*ALCANTARA WIND FARM  
PROVINCE OF MESSINA, SICILY  
TECHNICAL DUE DILIGENCE ON FOUNDATIONS OF  
SELECTED WTGs*

***REPORT***

*Date: Nov 30, 2013*

**Fig. 2-Ea**  
**WTG 110**  
 Plinth Plan with Position of Demolition Areas A1, A2, A3

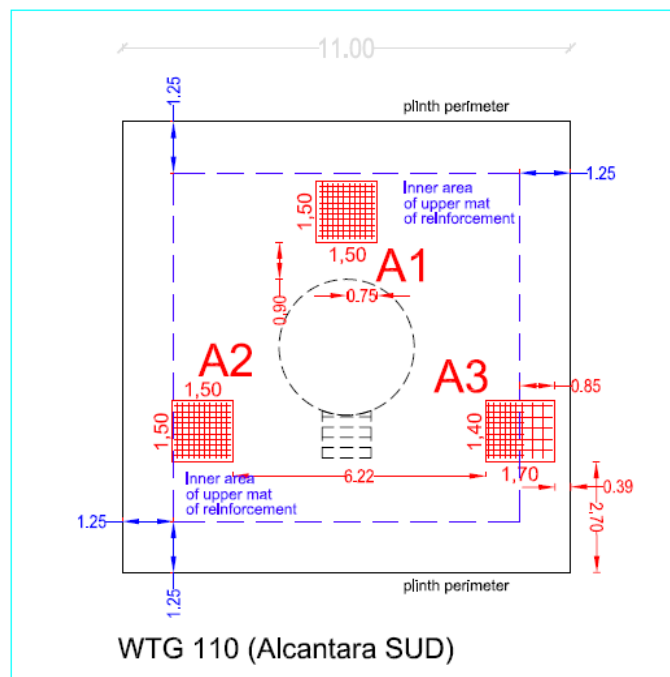
- **A1:** 2 no. layers of 24 mm diameter bars (measured by gauge) were observed, positioned at 125 mm centre distance on both layers (A1 was all in inner area of upper mat of reinforcement);
- **A2:** 2 no. layers of 24 mm diameter bars (measured by gauge) were observed, positioned at 125 mm centre distance on both layers (A2 was all in inner area of upper mat of reinforcement);
- **A3:** 2 no. layers of 24 mm diameter bars (measured by gauge) were observed, spacing changed from 125 mm to 250 mm centre distance because A3 contained the both the inner and outer area of upper mat reinforcement).

- **re-bars in compliance with design** (please refer to Chapter 2)
- **quality of workmanship: very good.**

**Fig. 2-F**  
**WTG 118**  
 Plinth Plan with Position of Demolition Areas A1, A2, A3

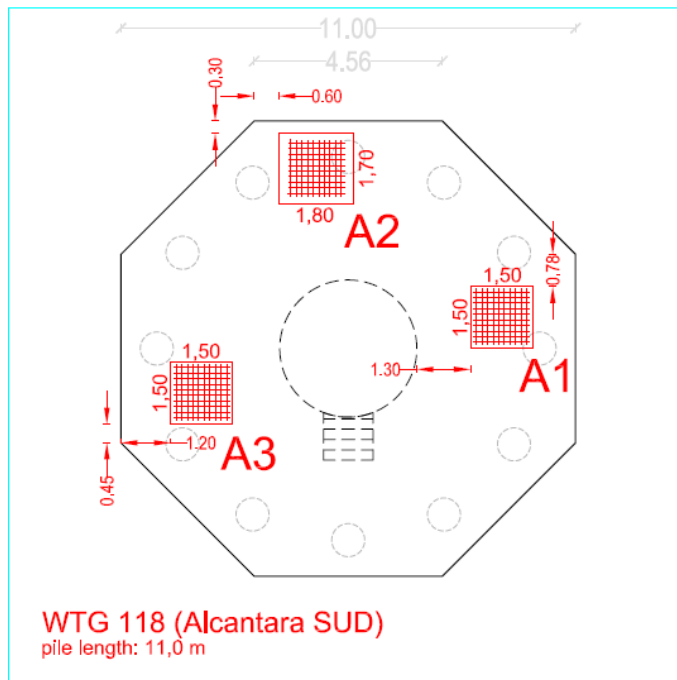
- **A1:** 2 no. layers of 24 mm diameter bars (measured by gauge) were observed, positioned at 135 mm centre distance on both layers (measured by gauge);
- **A2:** 2 no. layers of 24 mm diameter bars (measured by gauge) were observed, positioned at 135 mm centre distance on both layers (measured by gauge);
- **A3:** 2 no. layers of 24 mm diameter bars (measured by gauge) were observed, positioned at 135 mm centre distance on both layers (measured by gauge).

- **re-bars in compliance with design** (please refer Chapter 2)
- **quality of workmanship: very good.**

**Fig. 2-G**  
**WTG 130**  
 Plinth Plan with Position of Demolition Areas A1, A2, A3

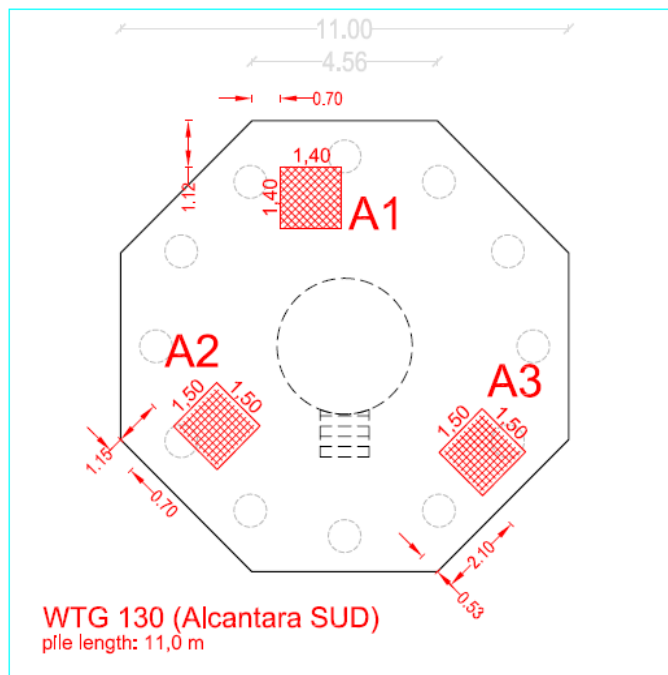
- **A1:** 2 no. layers of 24 mm diameter bars (measured by gauge) were observed, positioned at 135 mm centre distance on both layers (measured by gauge);
- **A2:** 2 no. layers of 24 mm diameter bars (measured by gauge) were observed, positioned at 135 mm centre distance on both layers (measured by gauge);
- **A3:** 2 no. layers of 24 mm diameter bars (measured by gauge) were observed, positioned at 135 mm centre distance on both layers (measured by gauge).

- re-bars in compliance with design (please refer to Chapter 2)
- quality of workmanship: very good.

**Fig. 2-Ga**  
**WTG 133**  
 Plinth Plan with Position of Demolition Areas A1, A2, A3

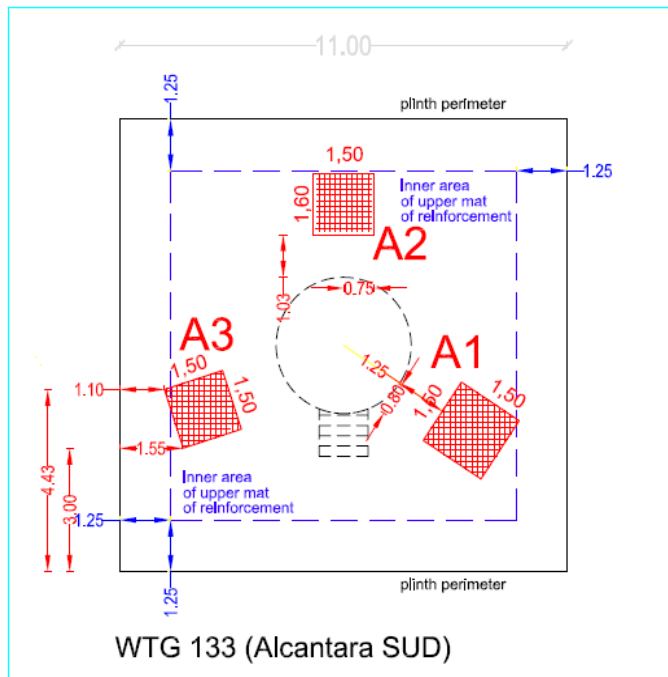
- **A1:** 2 no. layers of 24 mm diameter bars (measured by gauge) were observed, positioned at 125 mm centre distance on both layers (A1 was all in inner area of upper mat of reinforcement);
- **A2:** 2 no. layers of 24 mm diameter bars (measured by gauge) were observed, positioned at 125 mm centre distance on both layers (A2 was all in inner area of upper mat of reinforcement);
- **A3:** 2 no. layers of 24 mm diameter bars (measured by gauge) were observed, positioned at 125 mm centre distance on both layers (A3 was all in inner area of upper mat of reinforcement).

- re-bars in compliance with design (please refer to Chapter 2)
- quality of workmanship: very good.

**Fig. 2-H**  
**WTG 142**  
 Plinth Plan with Position of Demolition Areas A1, A2, A3

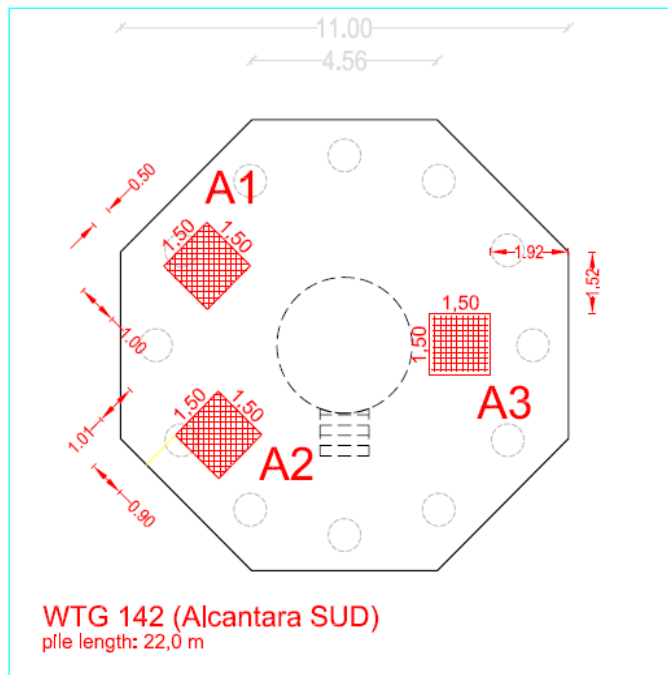
- **A1:** 2 no. layers of 24 mm diameter bars (measured by gauge) were observed, positioned at 135 mm centre distance on both layers (measured by gauge);
- **A2:** 2 no. layers of 24 mm diameter bars (measured by gauge) were observed, positioned at 135 mm centre distance on both layers (measured by gauge);
- **A3:** 2 no. layers of 24 mm diameter bars (measured by gauge) were observed, positioned at 135 mm centre distance on both layers (measured by gauge).

- re-bars in compliance with design (please refer to Chapter 2)
- quality of workmanship: very good.

**Fig. 2-I**  
**WTG 214**  
 Plinth Plan with Position of Demolition Areas A1, A2, A3

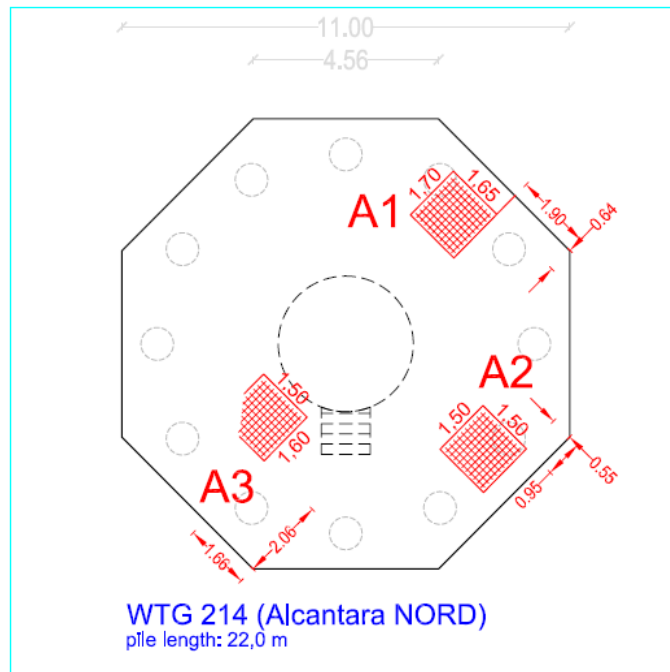
- **A1:** 2 no. layers of 24 mm diameter bars (measured by gauge) were observed, positioned at 135 mm centre distance on both layers (measured by gauge);
- **A2:** 2 no. layers of 24 mm diameter bars (measured by gauge) were observed, positioned at 135 mm centre distance on both layers (measured by gauge);
- **A3:** 2 no. layers of 24 mm diameter bars (measured by gauge) were observed, positioned at 135 mm centre distance on both layers (measured by gauge).

- re-bars in compliance with design (please refer to Chapter 2)
- quality of workmanship: very good.

**Fig. 2-J**  
**WTG 217**  
 Plinth Plan with Position of Demolition Areas A1, A2, A3

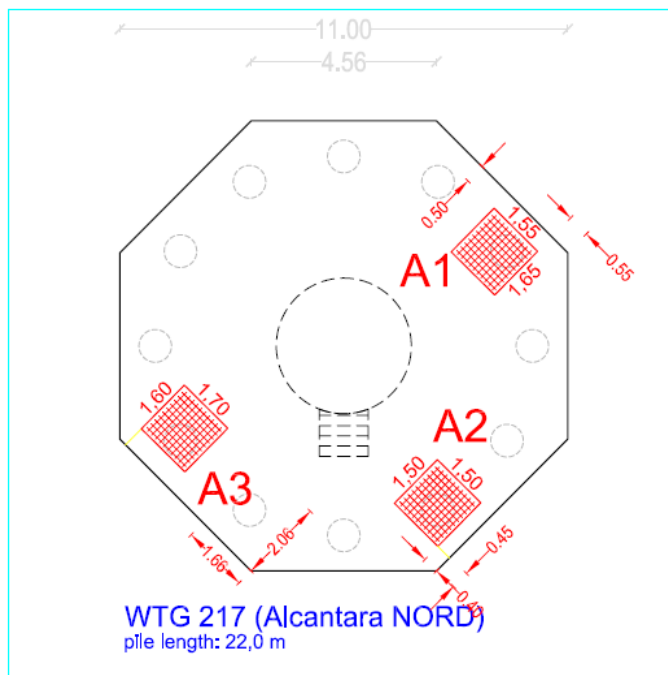
- **A1:** 2 no. layers of 24 mm diameter bars (measured by gauge) were observed, positioned at 135 mm centre distance on both layers (measured by gauge);
- **A2:** 2 no. layers of 24 mm diameter bars (measured by gauge) were observed, positioned at 135 mm centre distance on both layers (measured by gauge);
- **A3:** 2 no. layers of 24 mm diameter bars (measured by gauge) were observed, positioned at 135 mm centre distance on both layers (measured by gauge).

- re-bars in compliance with design (please refer to Chapter 2)
- quality of workmanship: very good.

**Fig. 2-K**  
**WTG 220**  
 Plinth Plan with Position of Demolition Areas A1, A2, A3

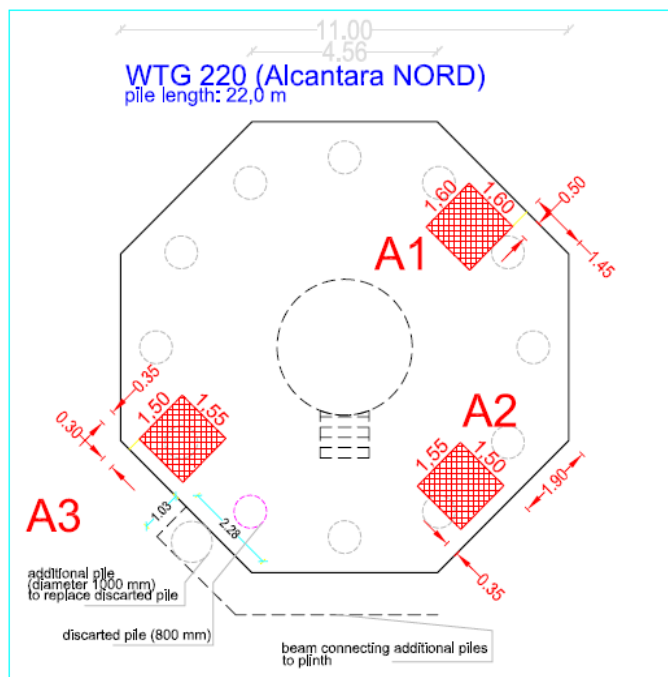
- **A1:** 2 no. layers of 24 mm diameter bars (measured by gauge) were observed, positioned at 135 mm centre distance on both layers (measured by gauge);
- **A2:** 2 no. layers of 24 mm diameter bars (measured by gauge) were observed, positioned at 135 mm centre distance on both layers (measured by gauge);
- **A3:** 2 no. layers of 24 mm diameter bars (measured by gauge) were observed, positioned at 135 mm centre distance on both layers (measured by gauge).

- re-bars in compliance with design (please refer to Chapter 2)
- quality of workmanship: very good.

**Fig. 2-L**  
**WTG 310**  
 Plinth Plan with Position of Demolition Areas A1, A2, A3

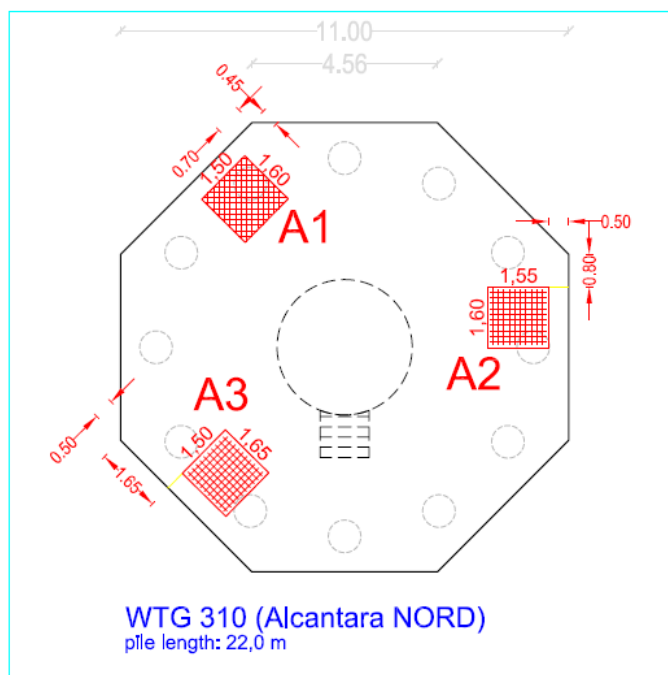
- **A1:** 2 no. layers of 24 mm diameter bars (measured by gauge) were observed, positioned at 135 mm centre distance on both layers (measured by gauge);
- **A2:** 2 no. layers of 24 mm diameter bars (measured by gauge) were observed, positioned at 135 mm centre distance on both layers (measured by gauge);
- **A3:** 2 no. layers of 24 mm diameter bars (measured by gauge) were observed, positioned at 135 mm centre distance on both layers (measured by gauge).

- re-bars in compliance with design (please refer to Chapter 2)
- quality of workmanship: very good.

**Fig. 2-M**  
**WTG 315**  
 Plinth Plan with Position of Demolition Areas A1, A2, A3

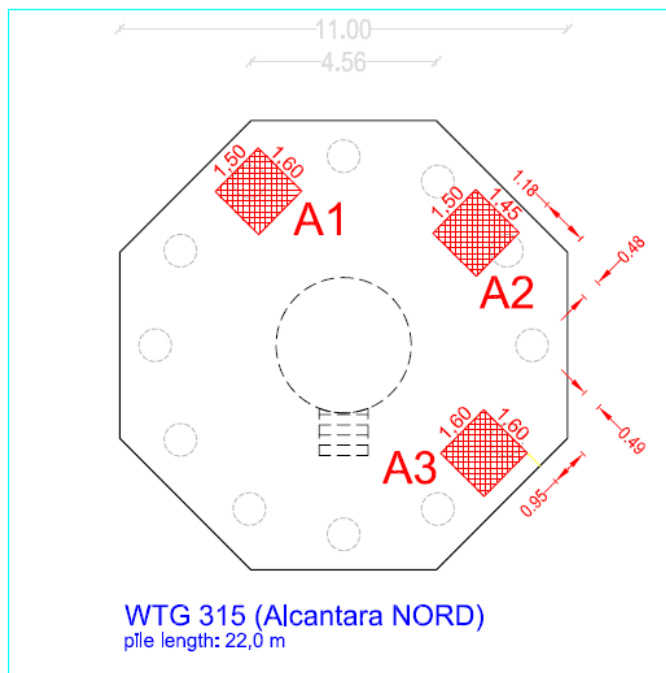
- **A1:** 2 no. layers of 24 mm diameter bars (measured by gauge) were observed, positioned at 135 mm centre distance on both layers (measured by gauge);
- **A2:** 2 no. layers of 24 mm diameter bars (measured by gauge) were observed, positioned at 135 mm centre distance on both layers (measured by gauge);
- **A3:** 2 no. layers of 24 mm diameter bars (measured by gauge) were observed, positioned at 135 mm centre distance on both layers (measured by gauge).

- re-bars in compliance with design (please refer to Chapter 2)
- quality of workmanship: very good.

**Foundation Plan**

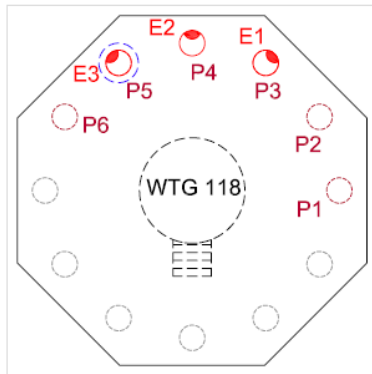
Conclusion: Pile reinforcement is found in compliance with design (please refer to Fig. 3-B)

Piles exposed with excavation: P1, P2, P3, P4, P5, P6 - Piles where SIT test was performed: E1, E2, E3

Pile chosen for PS test: P5 = E3

**Foundation Plan**

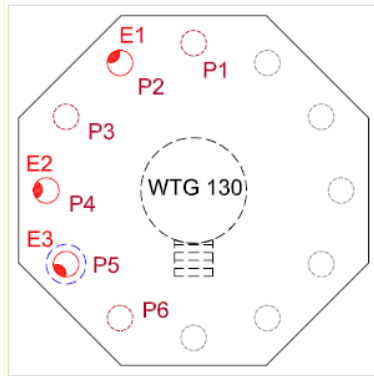
Conclusion: Pile reinforcement is found in compliance with design (please refer to Fig. 3-B)

Piles exposed with excavation: P1, P2, P3, P4, P5, P6

Pile chosen for PS test: P5 = E3

**Foundation Plan**

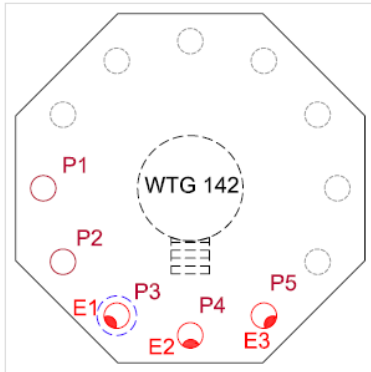
Conclusion: Pile reinforcement is found in compliance with design (please refer to Fig. 3-C)

Piles exposed with excavation: P1, P2, P3, P4, P5 ( P6 not excavated because of stability of slope)

Pile chosen for PS test: P3 = E1

**Foundation Plan**

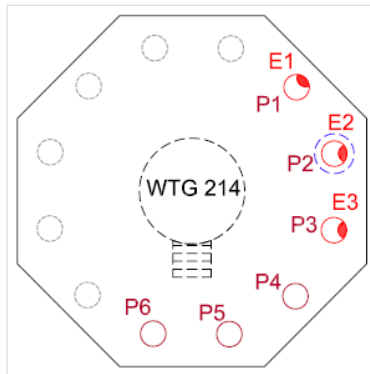
Conclusion: Pile reinforcement is found in compliance with design (please refer to Fig. 3-C)

Piles exposed with excavation: P1, P2, P3, P4, P5, P6

Pile selected for PS test: P2 = E2

**Foundation Plan**

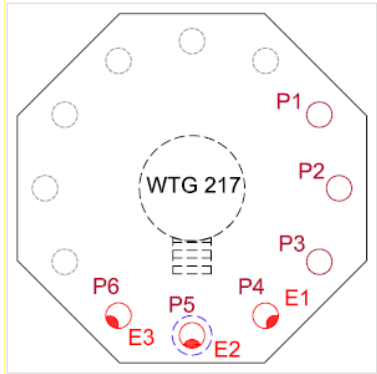
*Piled Foundation - Pile length: 22,0 m*  
*Date when inspection was carried out: September 10<sup>th</sup>, 2013;*  
*Inspecting Officers: G. La Tona (SER), L.C. Speranza (Scangea), GeoLAB Field Technicians.*  
*Conclusion: Pile reinforcement is found in compliance with design (please refer to Fig. 3-C)*

Piles exposed with excavation: P1, P2, P3, P4, P5, P6  
 Piles where SIT test was performed: E1, E2, E3  
 Pile selected for PS test: P5 = E2

**Foundation Plan**

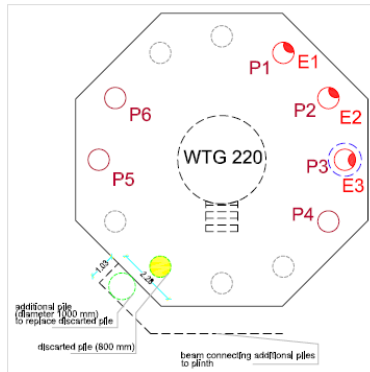
Conclusion: Pile reinforcement is found in compliance with design (please refer to Fig. 3-C)

Piles exposed with excavation: P1, P2, P3, P4, P5, P6

Pile selected for PS test: P3 = E3

**Foundation Plan**

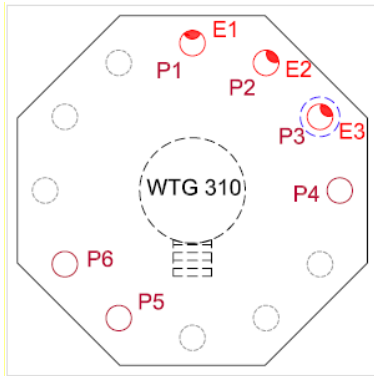
Conclusion: Pile reinforcement is found in compliance with design (please refer to Fig. 3-C)

Piles exposed with excavation: P1, P2, P3, P4, P5, P6

Pile selected for PS test: P3 = E3

**Foundation Plan**

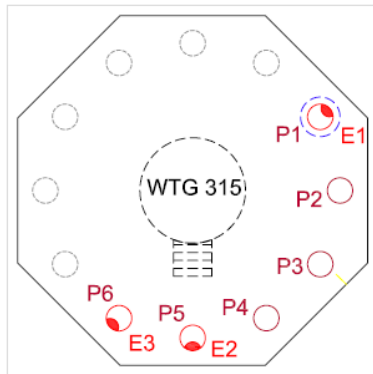
Conclusion: Pile reinforcement is found in compliance with design (please refer to Fig. 3-C)

Piles exposed with excavation: P1, P2, P3, P4, P5, P6

Pile selected for PS test: P1 = E1
